**TECHNICAL MEMORANDUM
NYU CORE
CEQR No. 11DCP121M**

B. DESCRIPTION OF THE ADDITIONAL POTENTIAL CPC MODIFICATIONS

Additional Potential CPC Modifications—
Reduced Mercer Building Light Well
Figure 1

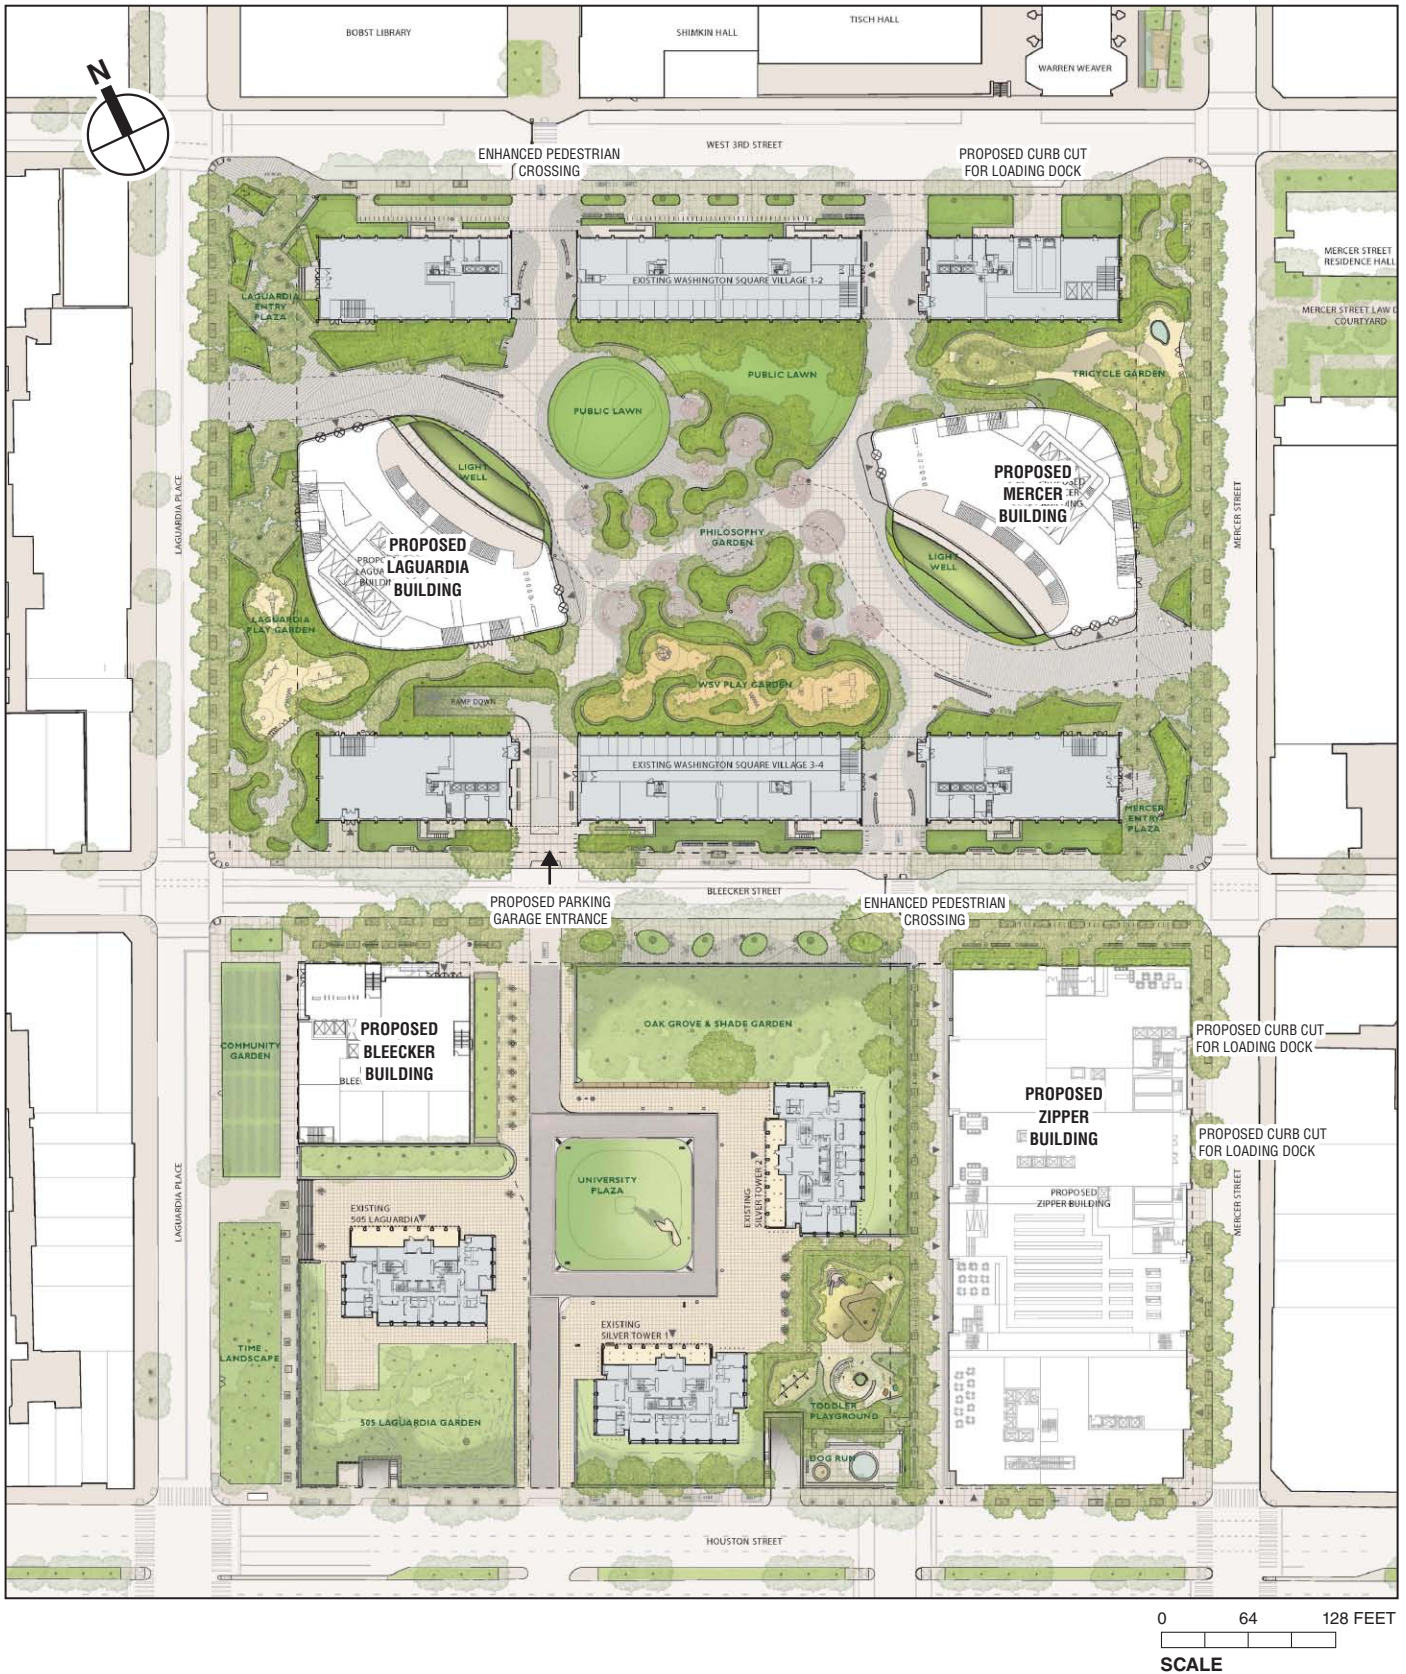
- Mercer Building—the proposed at-grade light well would be reduced in size from 5,762 square feet at grade to 3,233 square feet at grade; and
- Mercer and LaGuardia Buildings—a 10-foot setback of roof-top mechanical bulkheads would be added instead of no setback.

FEIS. However, the Modified Proposal, if approved, would include two design changes to the North Block: the size of the light well proposed for the Mercer Building would be reduced in size, resulting in an additional 0.06 acres of publicly accessible passive open space in the central open space area (see **Figure 1**); and the mechanical bulkheads on the roofs of the LaGuardia and Mercer Buildings would be set back by approximately 10 feet instead of no set back (i.e., the buildings would not rise flush for their full heights to the top of the bulkhead) (see **Figures 2 and 3**).

As compared with the Potential CPC Modifications, the Additional Potential CPC Modifications would slightly increase the amount of passive open space (from approximately 1.58 acres to approximately 1.64 acres) associated with the North Block’s central open space due to the reduction in size of the proposed Mercer Building’s light well. Further, accounting for the level of below-grade academic space in the proposed Bleecker Building that was not analyzed under the Potential CPC Modifications, there would be a slight increase in the number of workers within the Bleecker Building (from an estimated 166 to an estimated 187 persons). These minor changes would not alter the findings of the open space analyses presented in the FEIS. As shown in **Table 2**, as with the Potential CPC Modifications, by 2021 all open space ratios would be slightly improved as compared with future No Build conditions, and no significant adverse open space impacts would result from the Additional Potential CPC Modifications. As compared with the Potential CPC Modifications, the worker population associated with the fourth basement level of the proposed Bleecker Building would not be large enough to alter the open space ratios within the ¼-mile non-residential or ½-mile residential study areas.

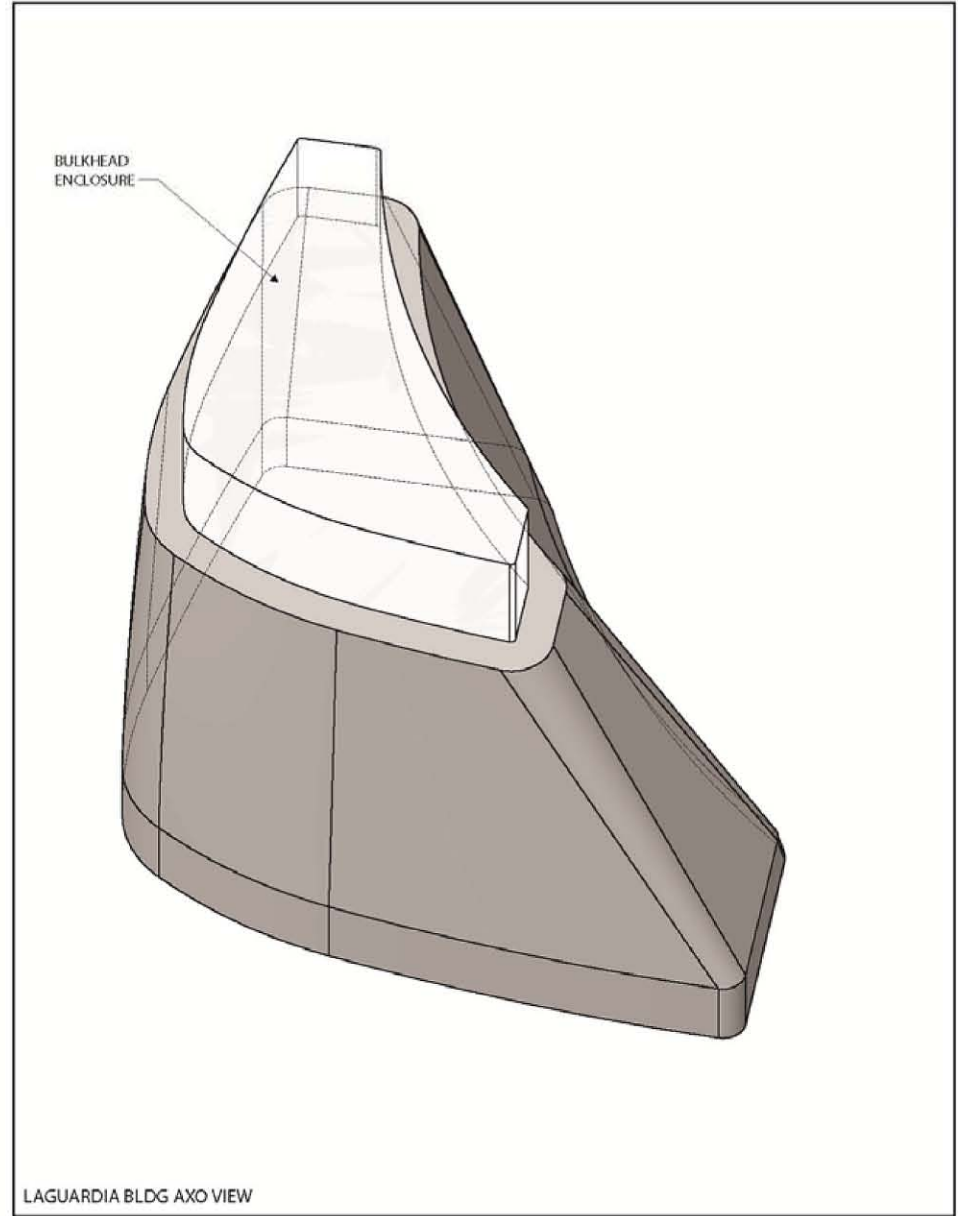
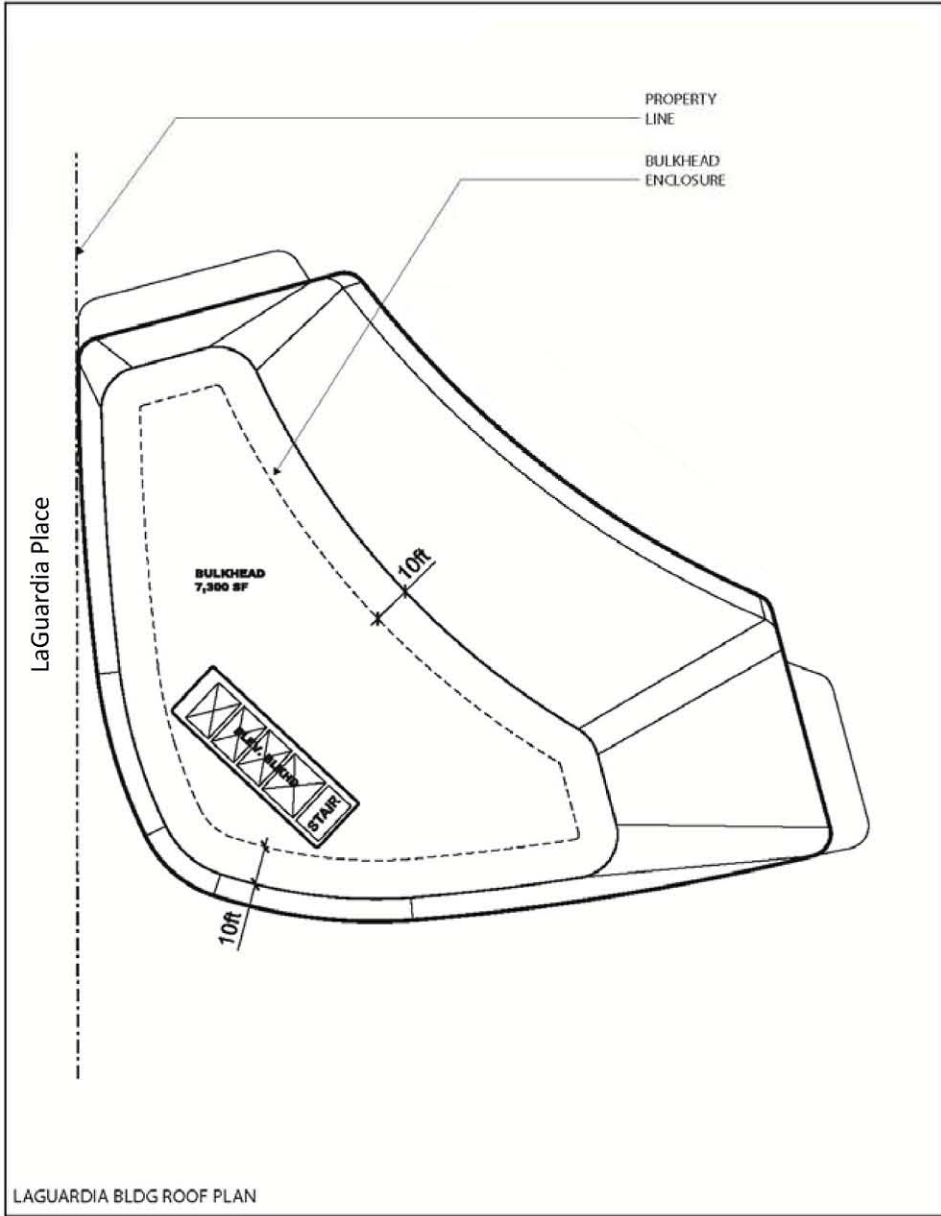
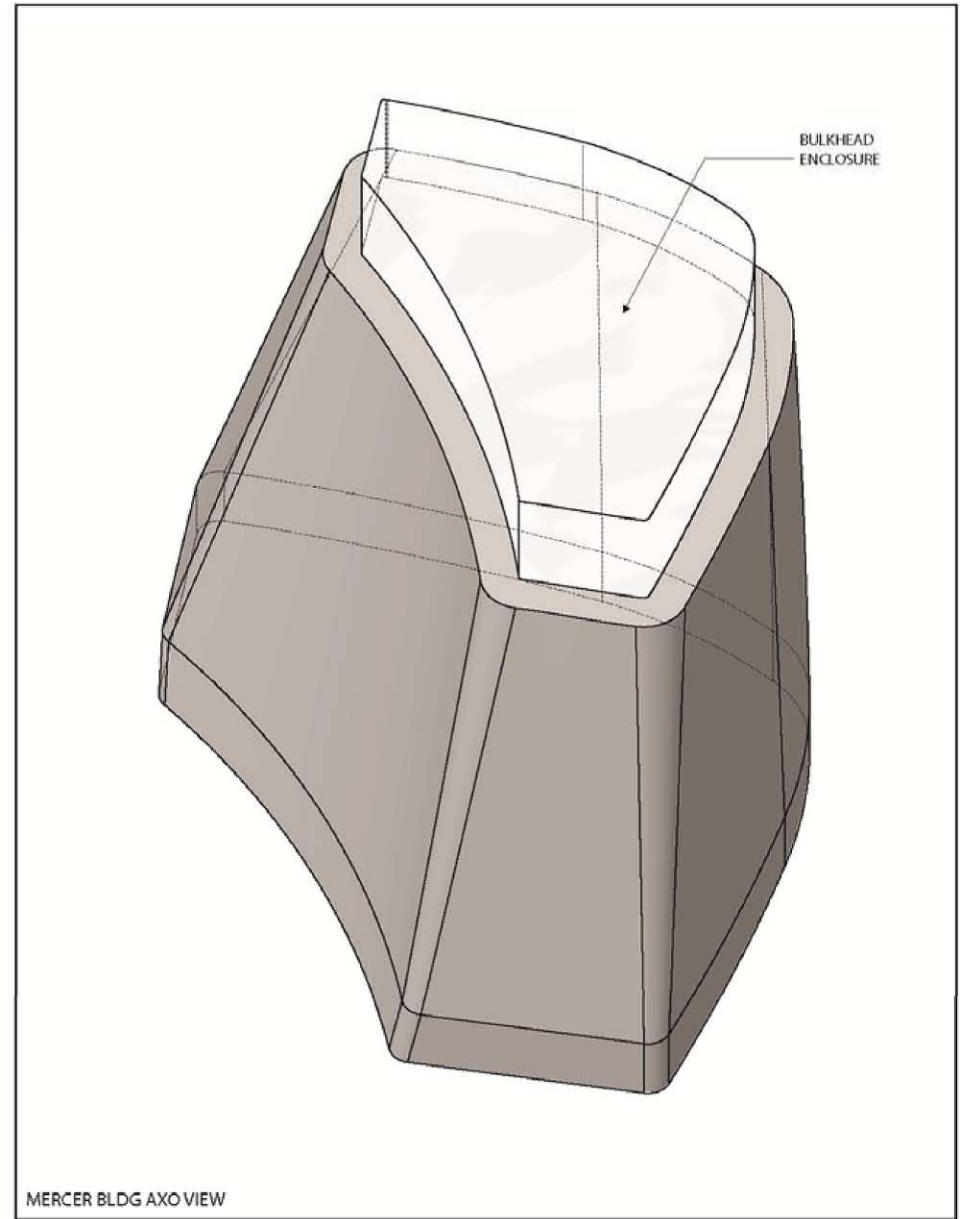
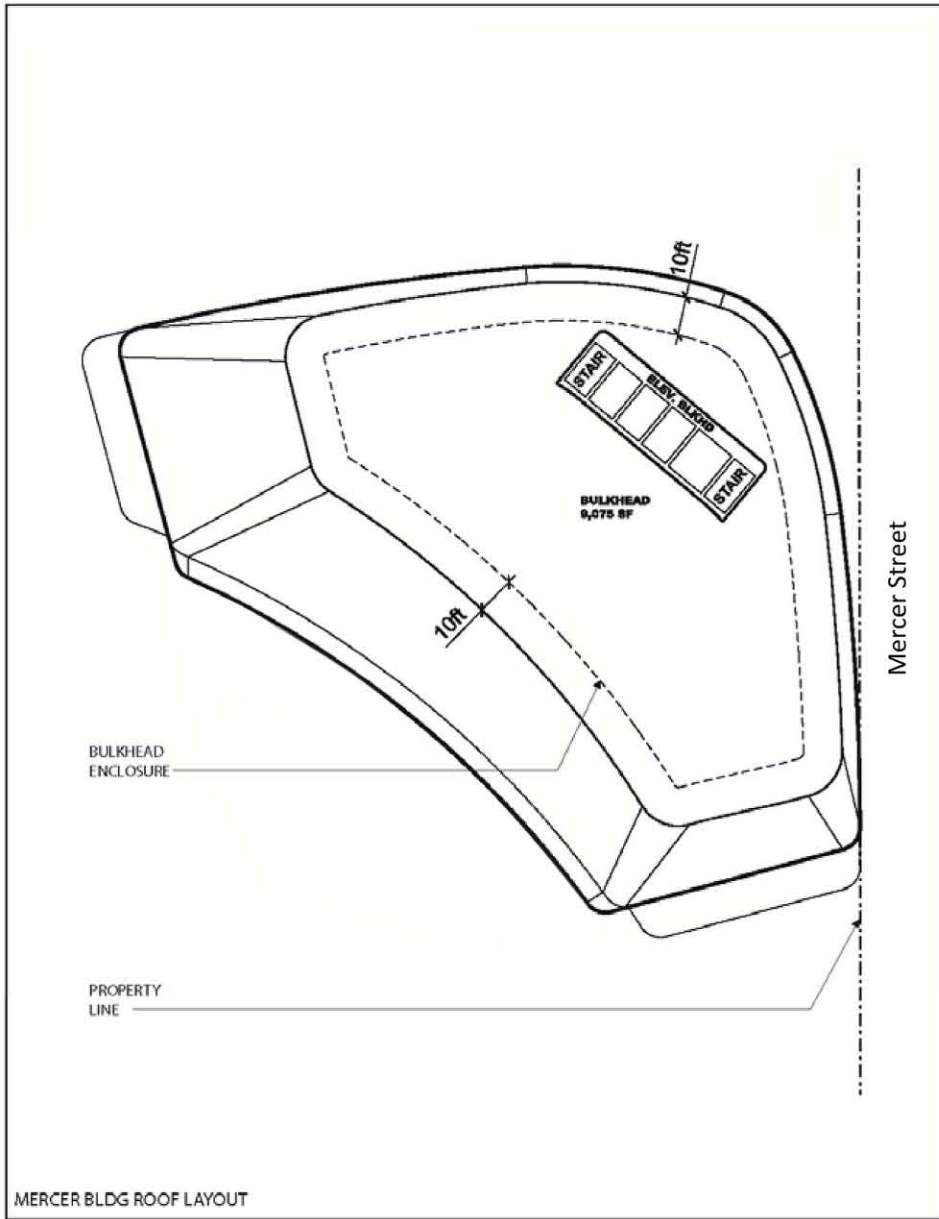
As illustrated in **Figures 2 and 3**, with the Additional Potential CPC Modifications, the mechanical bulkheads on the proposed LaGuardia and Mercer Buildings would be set back approximately 10 feet. Under the Potential CPC Modifications analyzed in Chapter 26 of the FEIS, setbacks for the mechanical bulkhead would not be required. The mechanical bulkheads represent the top 30 feet (approximately) of these two proposed buildings. An analysis of shadows with the 10-foot setbacks showed that as compared with the Potential CPC Modifications, the Modified Proposal would cast slightly smaller shadows on the North Block’s publicly accessible open spaces (generally in the range of 0–8 percent smaller, depending on the time of day) during much of the spring, summer and fall analysis periods (see **Figure 4**, which depicts the maximum incremental reduction in shadows as compared with the Potential CPC Modifications). In the winter, there would be virtually no difference in shadows, except for a brief period around noon when shadow from the LaGuardia Building with the Additional Potential CPC Modifications would be slightly smaller on the LaGuardia Entrance Plaza. In spring, summer and fall, the slightly smaller extent of shadows with the Additional Potential CPC Modifications would occur mostly on the LaGuardia Entrance Plaza, the Public Lawn and Philosophy Garden, and the Tricycle Garden. The reductions in extent of shadow would not be great enough with the Additional Potential CPC Modifications to substantively affect the

The Additional Potential CPC Modifications include required 10-foot setbacks of the mechanical bulkheads on the proposed LaGuardia and Mercer Buildings. With these modifications, the facades of the LaGuardia and Mercer Buildings would not rise flush for their full heights to the top of the bulkheads. As compared with the Proposed Actions and the Potential CPC Modifications analyzed in the FEIS, the required setbacks would reduce the perceived heights of the two buildings. As seen from the street, especially closer to the site, the visibility of the bulkheads would be minimized and the LaGuardia Building would appear from street-level vantage points very close to the LaGuardia Building to be approximately 128 feet tall (the height to the roof parapet) rather than 158 feet tall (the height to the top of the bulkhead), and the Mercer Building would appear from street-level vantage points very close to the Mercer Building to be approximately 162 feet tall (the height to the roof parapet) rather than 192 feet tall (the height to the top of the bulkhead). Therefore, with the 10-foot setbacks the LaGuardia and Mercer Buildings would appear, to the pedestrian in close proximity to the LaGuardia or Mercer Building, to be approximately 30 feet shorter. From farther away, however, the bulkheads would be more visible, and there would be little difference in appearance to the pedestrian between the LaGuardia and Mercer Buildings with the Additional Potential CPC Modifications and those analyzed in the FEIS.

Shadows that would not occur with the Additional Potential CPC Modifications as compared to the Potential CPC Modifications

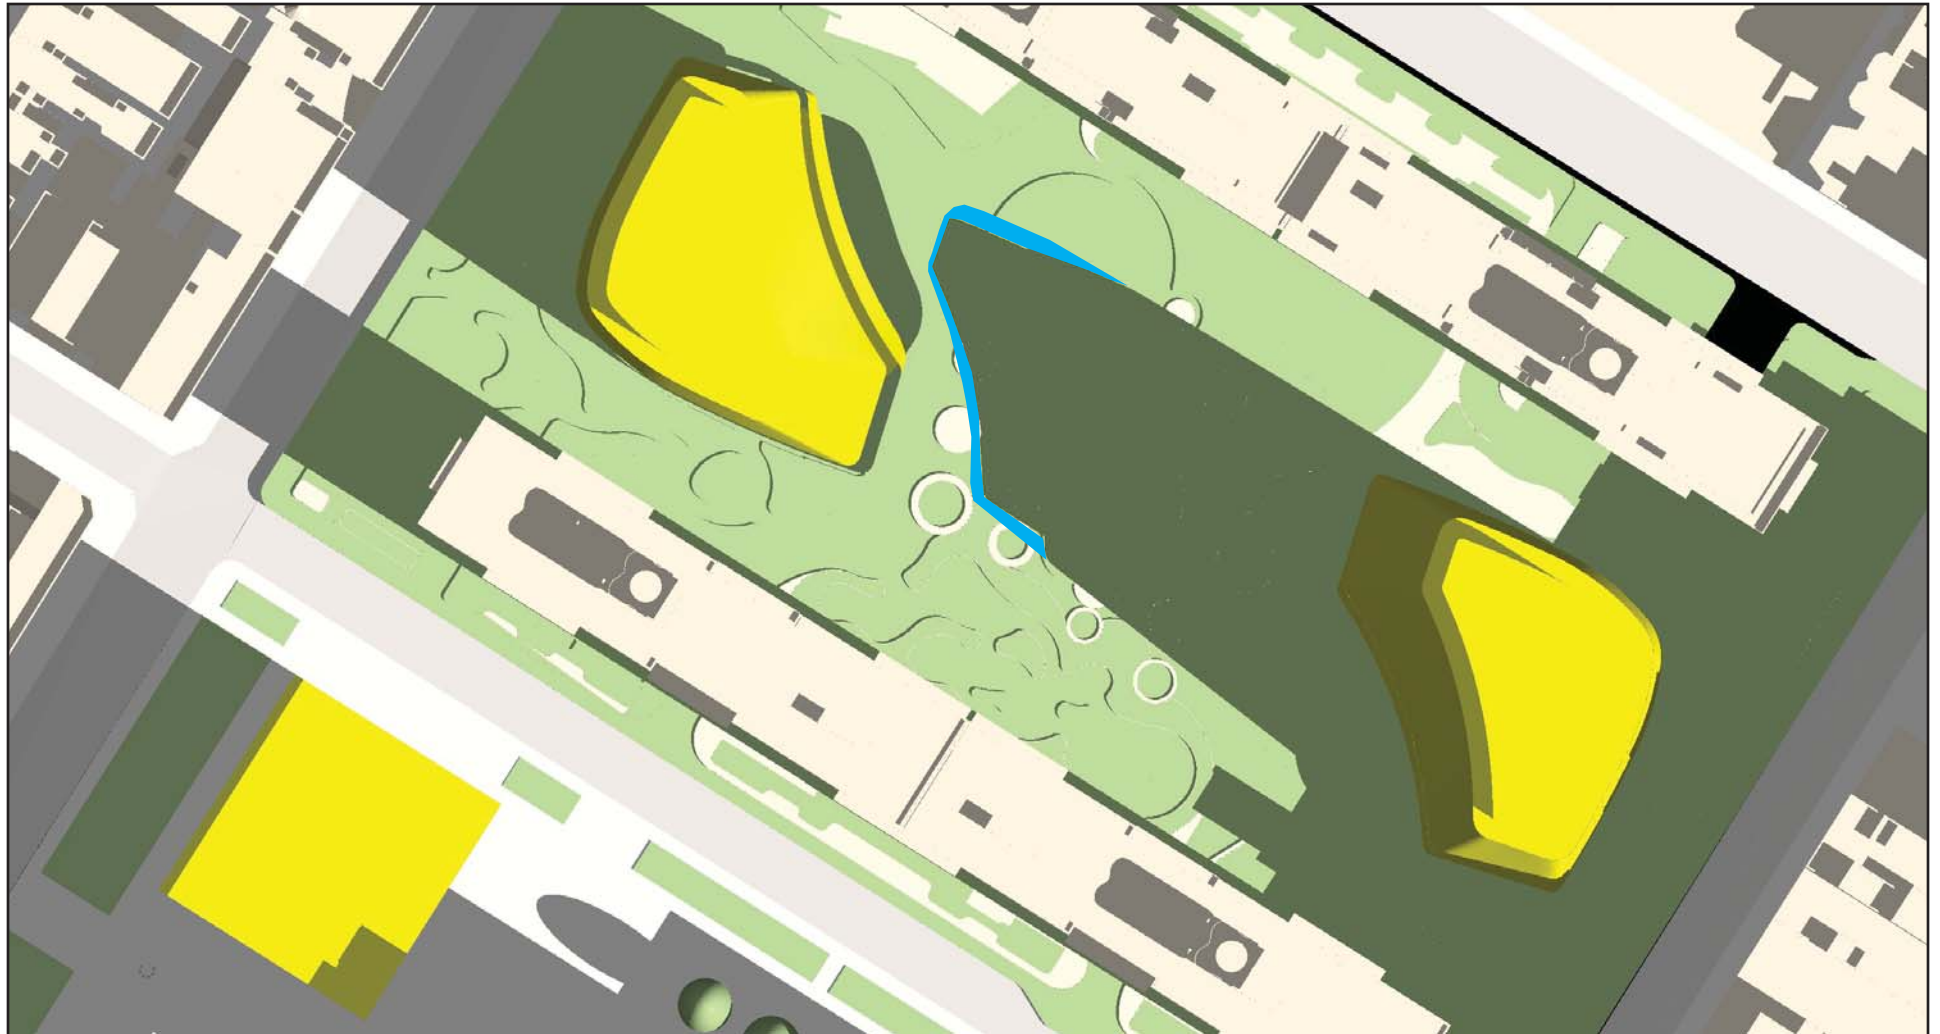
estimates of percent coverage reported in Appendix H of the FEIS, and the slight reduction in project shadowing would be only marginally perceptible in shadow figures presented in the FEIS. Therefore, the Additional Potential CPC Modifications would not alter the conclusions of the shadows analysis presented in the FEIS.
